NPP TRICASTIN 3&4 LTO ENVIRONMENTAL IMPACT ASSESSMENT

Expert Statement

Contracting authority Federal Ministry of Agriculture and Forestry, Climate and Environmental Protection, Regions and Water Management; Directorate General VI - Environment and Climate; Directorate VI/8 General Coordination of Nuclear Affairs

Figure 3: French active fault database and location of the Tricastin reactors (re-drawn from: JOMARD et al., 2017; RITZ et al. 2021). Circles around Tricastin indicate the site near-region and site region according to IAEA (2022) (radius 25 and 50 km from the site, respectively).

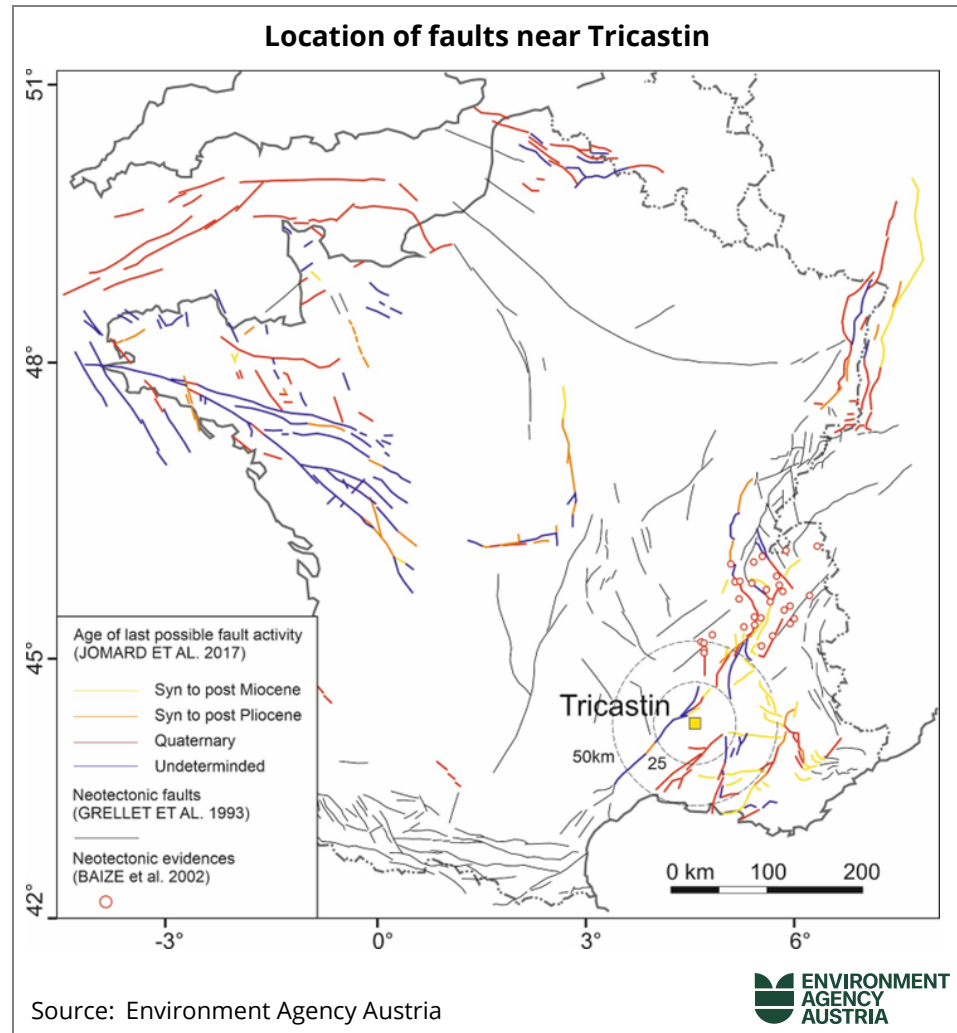
In tectonic terms, the Tricastin site is located near or within the Bresse Graben System, which together with the lower and upper Rhine Graben forms the Cenozoic European rift system. EIA-REPORT T3, D.2 (2026, p. 134) and EIA-REPORT T4, D.2 (2026, p. 134) provide evidence that EDF is aware that geological and seismological data indicate the existence of several active faults in the near-region and region around the Tricastin site, naming the active Mimes-, Clanseyes- and Cavenen fault (EIA-REPORT T3/4, D.2 2026, p. 135; 134) and mentioning neotectonic evidence from four sites along the Nimes fault. This is in line with data by JOMARD et al. (2017) who identified numerous Quaternary faults in the near-region and region (IAEA 2022) of Tricastin (Figure 3).

Figure 6: Cloud arrival time for the release category FK2

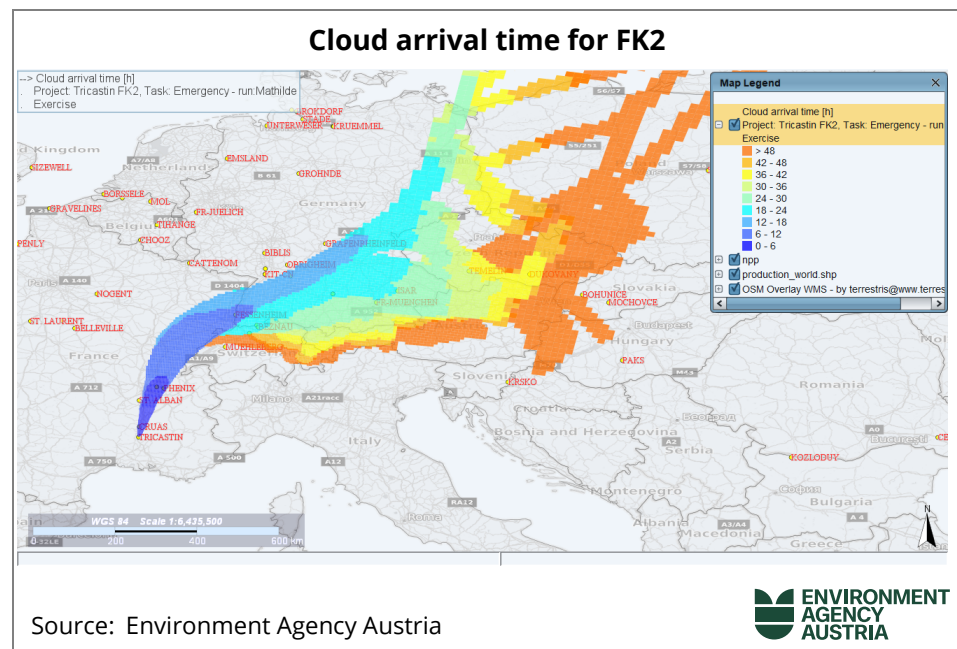
Figure 6 presents information on cloud arrival time, indicating when the radioactive cloud is expected to reach the affected country. In both scenarios, with the release assumed to start on 13 March 2026 at 10:00 UTC, the cloud is projected to reach Austrian territory in less than 30 hours. Meteorological conditions are the dominant factor influencing cloud arrival time, and this result may vary significantly under different weather conditions.

Figure 7: Ground contamination with Cs-137 for the release category FK2

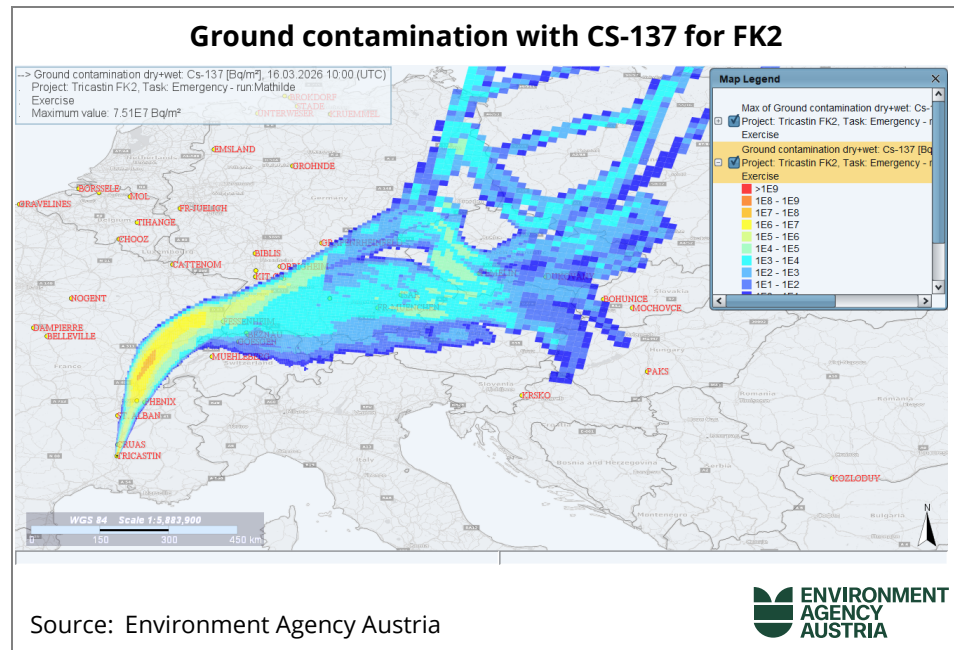
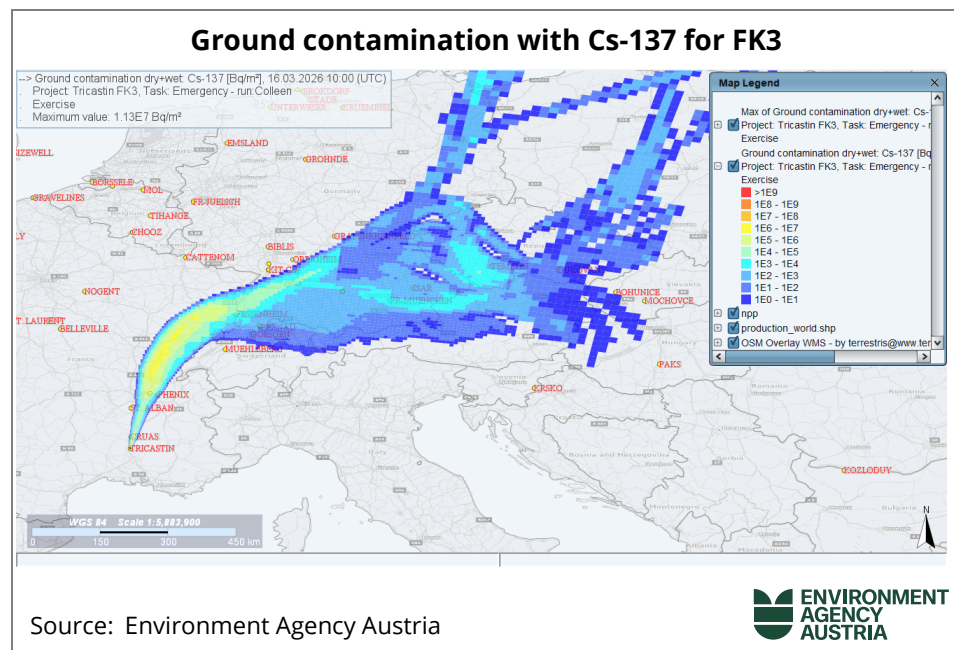
The results of the JRODOS calculations demonstrate that contamination levels in Austria exceeding 650 Bq/m² are possible. The maximum calculated ground deposition exceeds 1×10⁴ Bq/m² for release category FK2 and 1×10³ Bq/m² for release category FK3.

These results indicate that transboundary radiological consequences more significant than those presented in the EIA documents cannot be excluded. The probability of occurrence of such contamination levels was not assessed within this calculation.
